SERVICE BULLETIN No.1094

COACH MODEL	: T815/9 45ft, T900 and T2100 Series coaches
BULLETIN TYPE	: Field Change Program
MANUAL & SECTION	: Maintenance Manual: Chapter 7 - Steering Spare Parts Manual: Section 642006 – Steering linkage
PARTS BOOK REVISION	: No
DATE	: June 3rd, 2003
SUBJECT	: Steering linkage idler arm - noise
TERMS & CONDITIONS	: Refer to the Warranty Information in this Bulletin.

Figure 1: Steering linkage idler arm # VH R0 10538746 with grease nipple location shown

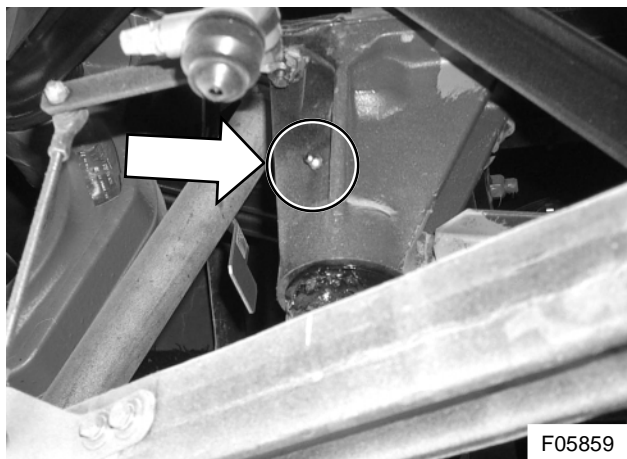
- Owners and operators of the above-mentioned coaches are requested to check whether the steering linkage idler arm has been equipped with a grease nipple (see Figure 1).
If no grease nipple has been fitted, please contact ABC Customer Care & Parts Source.

- Service records have shown that, after being in service for several years, some of the above-mentioned coach models develop idler arm noise while driving.
- To address the issue, Van Hool offer a free replacement idler arm featuring a grease nipple in the housing. These assemblies come pre-lubricated, ready to fit and include detailed fitting instructions.
- Once installed, the idler arm assembly should be thoroughly greased through every 6,000 miles to remove any contaminated grease that may have developed in the period between maintenance intervals.
- Customers with coaches, which are already equipped with an idler arm featuring a grease nipple, are reminded that these assemblies should be lubricated regularly, as stated in the Maintenance Manual.
